2010 PUMP STATION REHABILITATION
KINGS ROW 1 PS
CIVIL SITE AND MECHANICAL PLANS

SHEET NUMBER
C2
 9 OF 48

2010 PUMP STATION REHABILITATION
QUEEN WAY PS
CIVIL SITE AND MECHANICAL PLANS

SHEET NUMBER
C6
13 OF 48

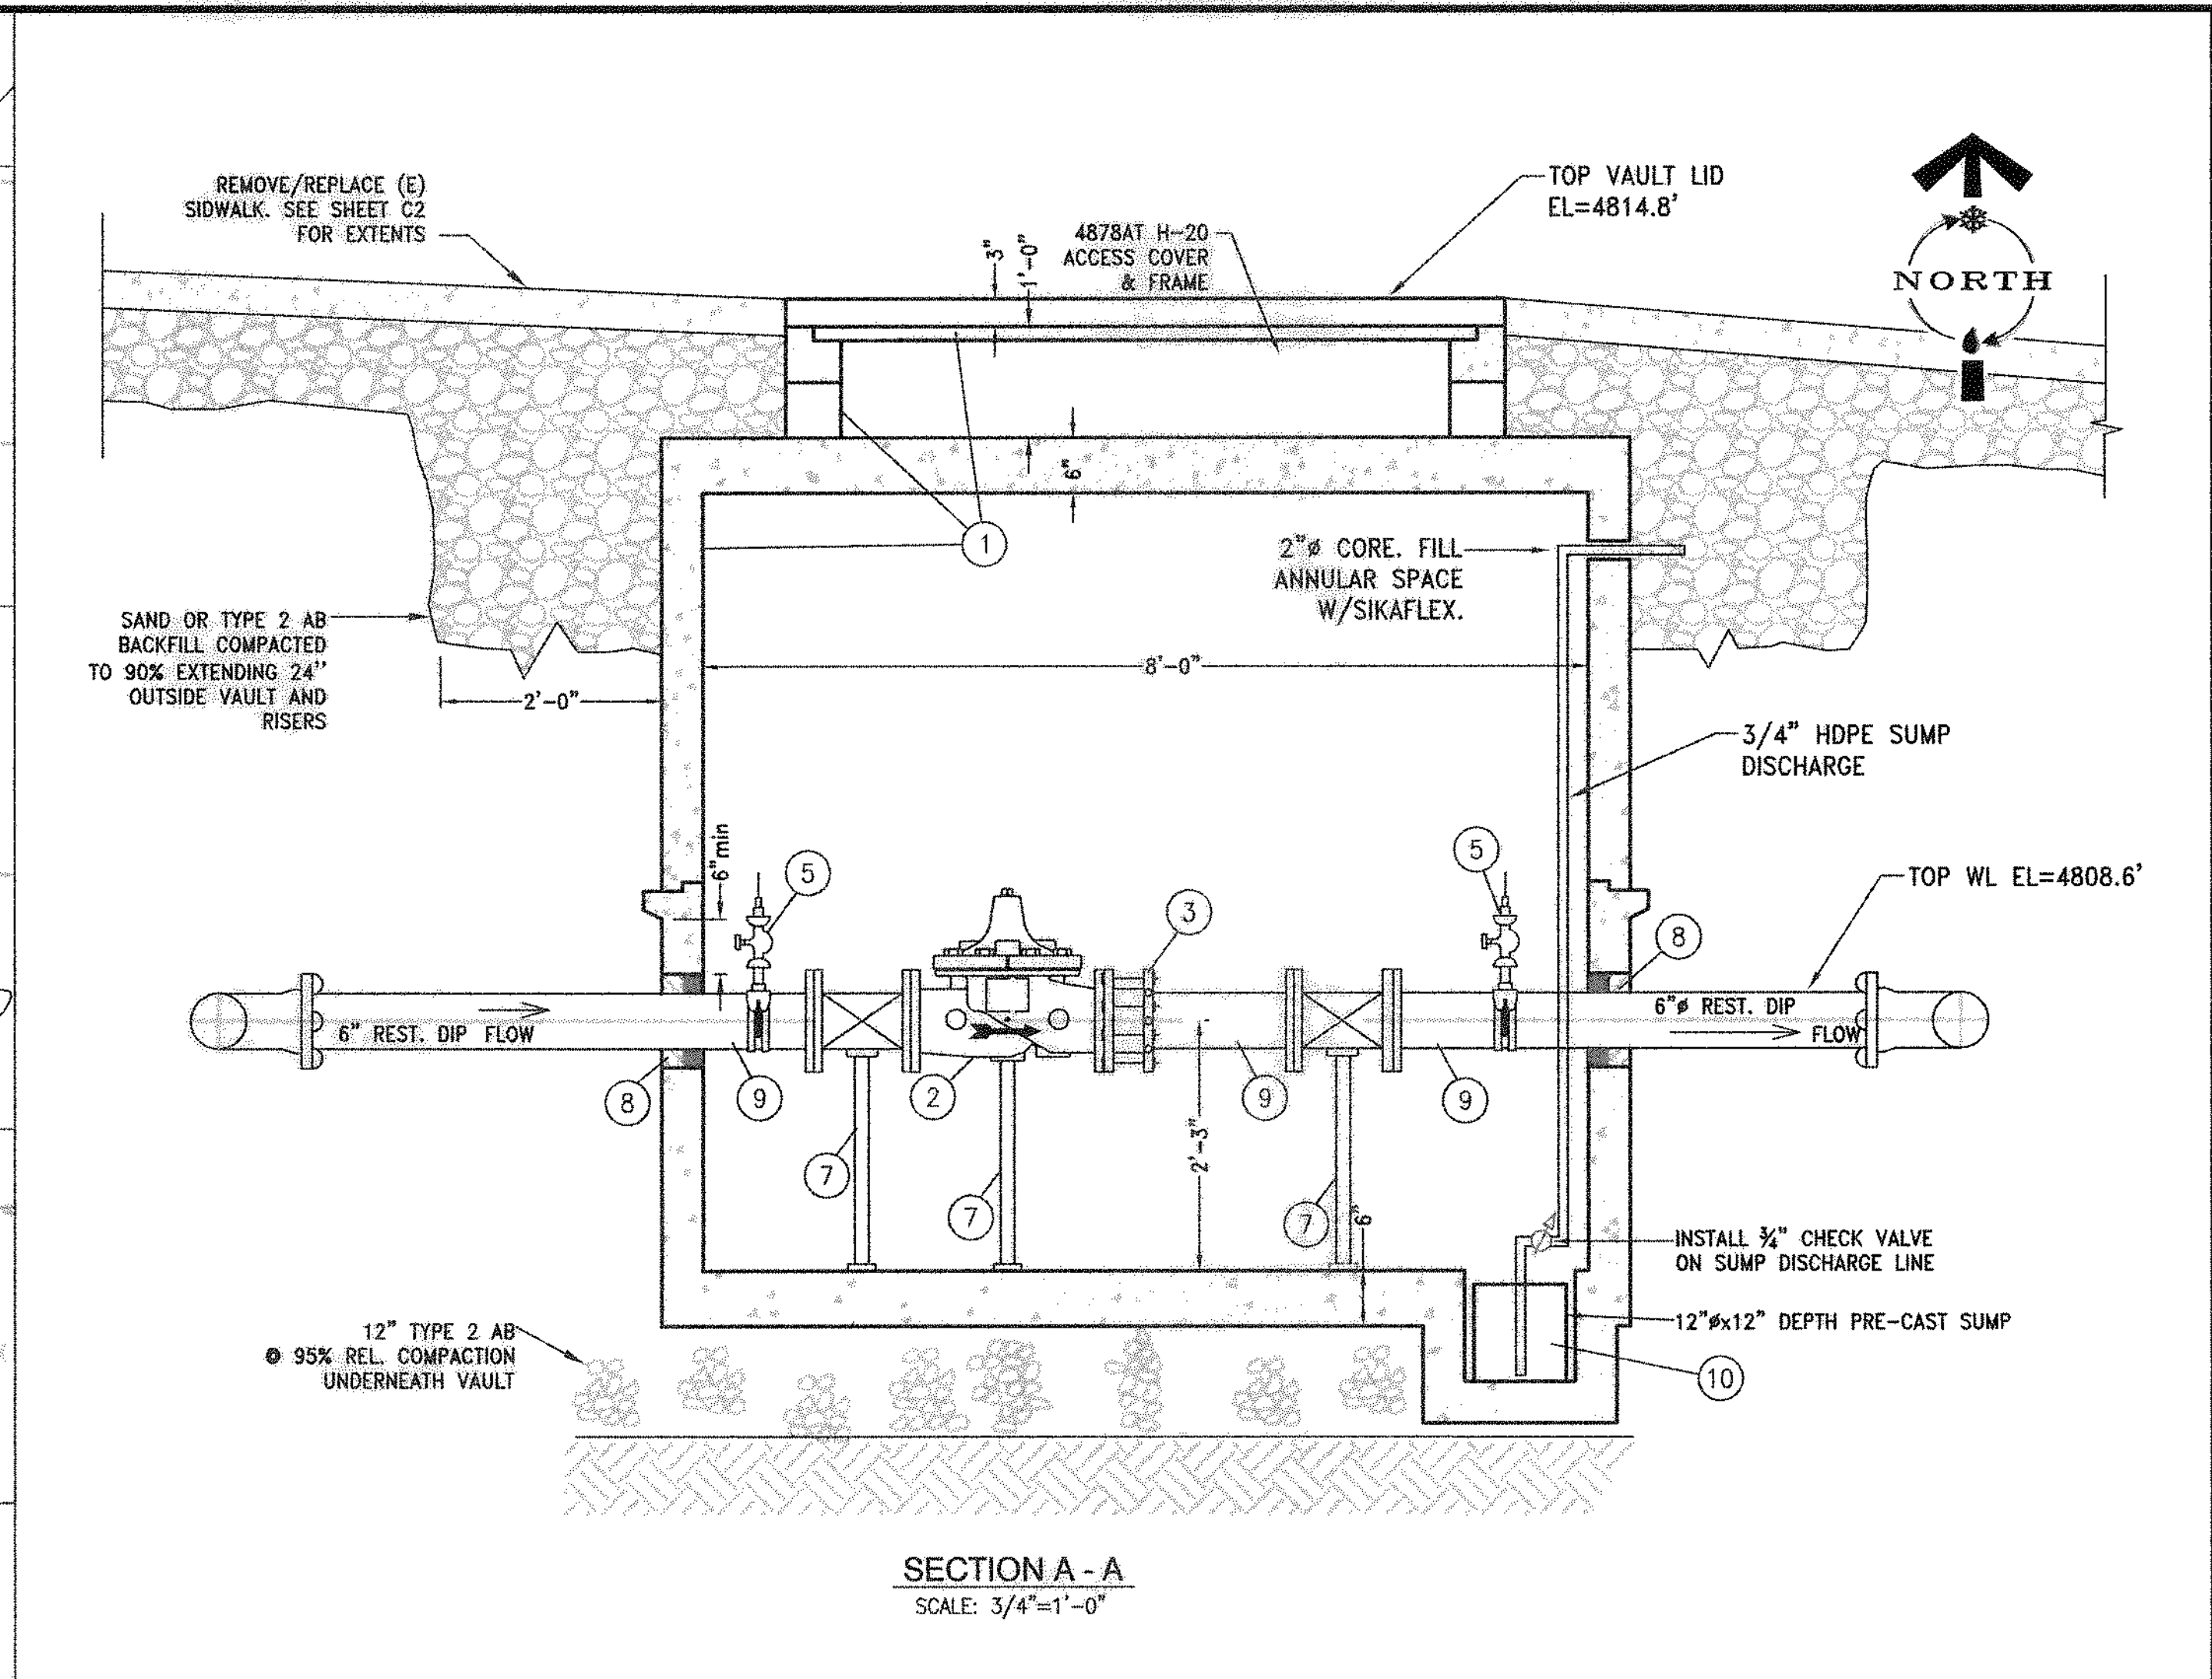
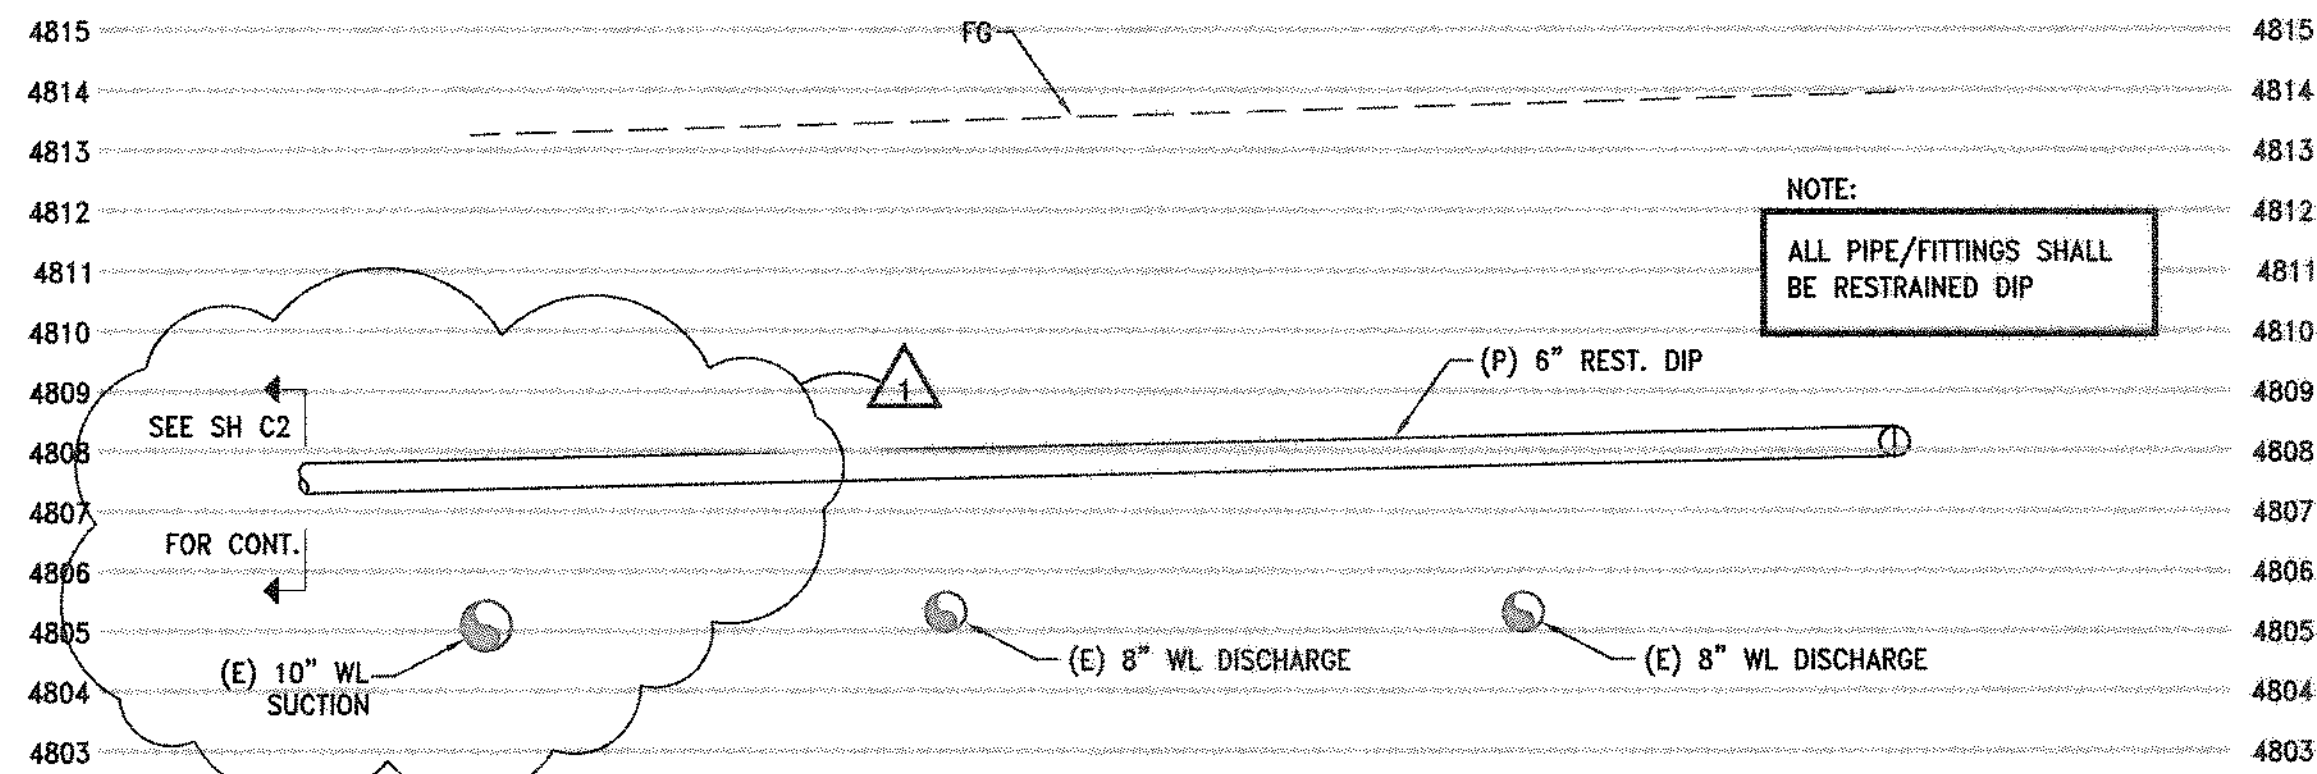
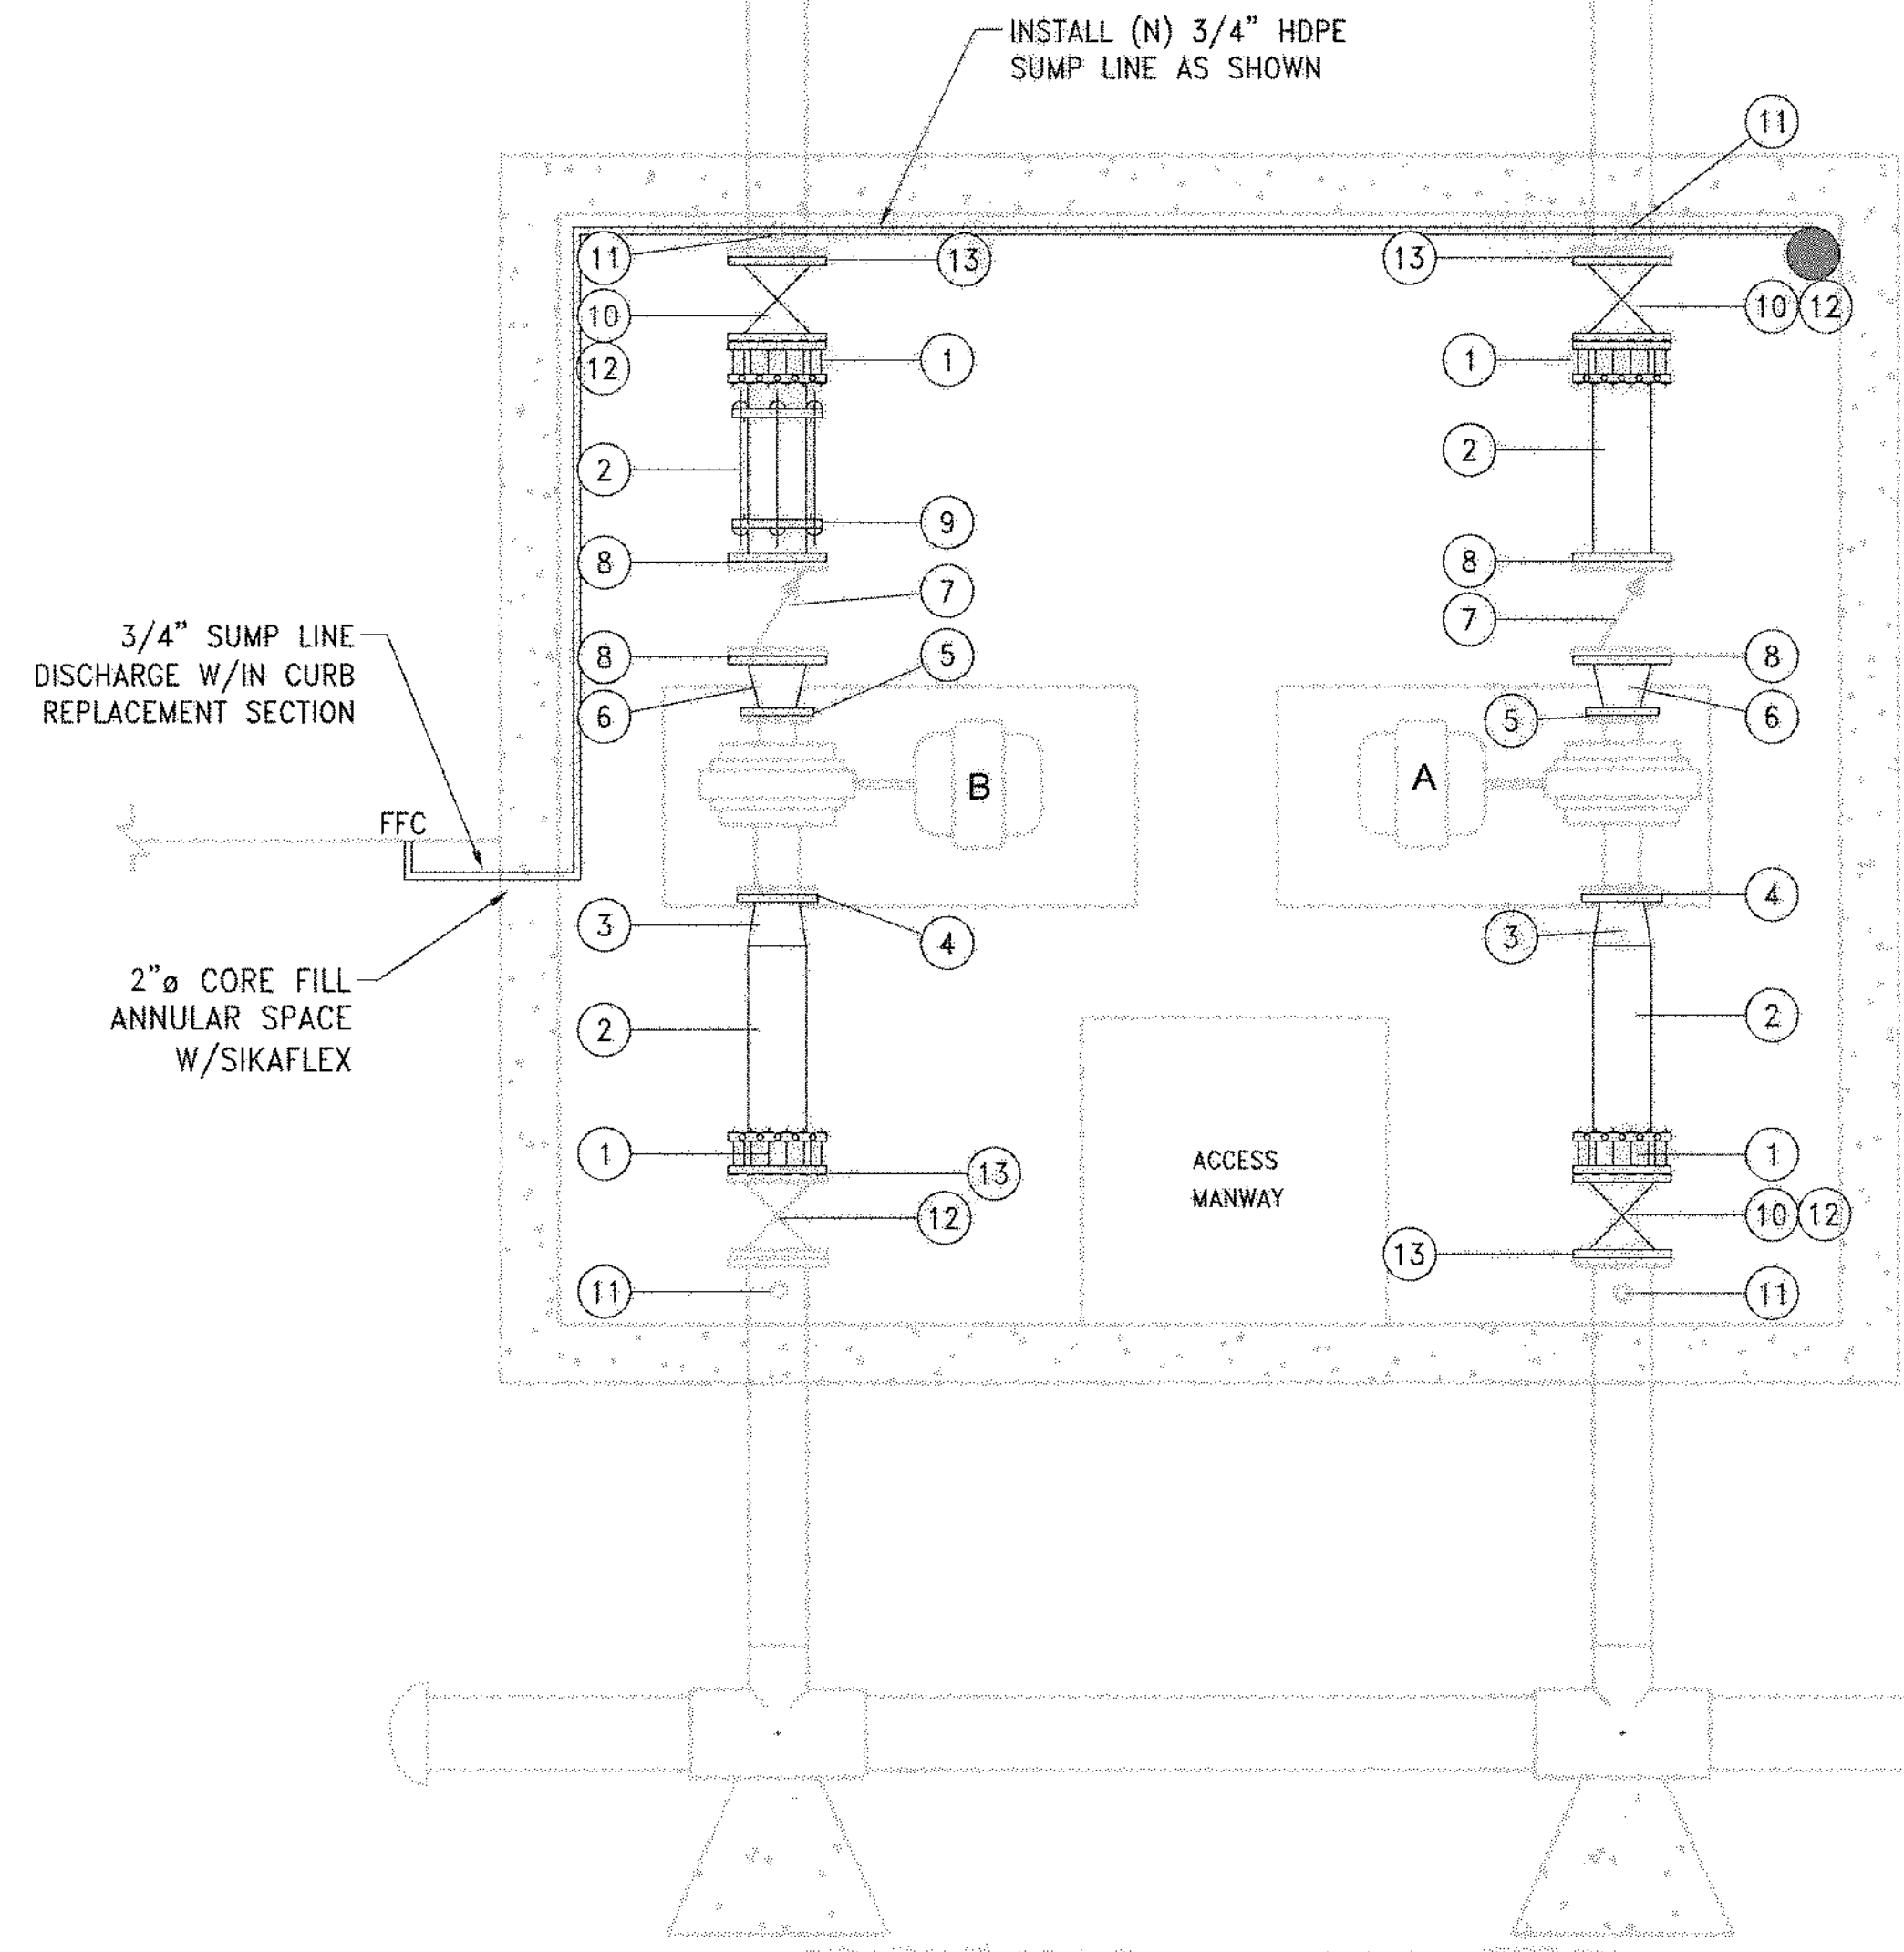
REVISION	DESCRIPTION	BY	APP	DATE
ADDENDUM #2	REVISED POINT OF CONNECTION TO EXISTING 12" SEE SHEET C2 ISSUED IN ADDENDUM 2 FOR PIPE LENGTH/FITTING REQUIREMENTS.	SB		1/10
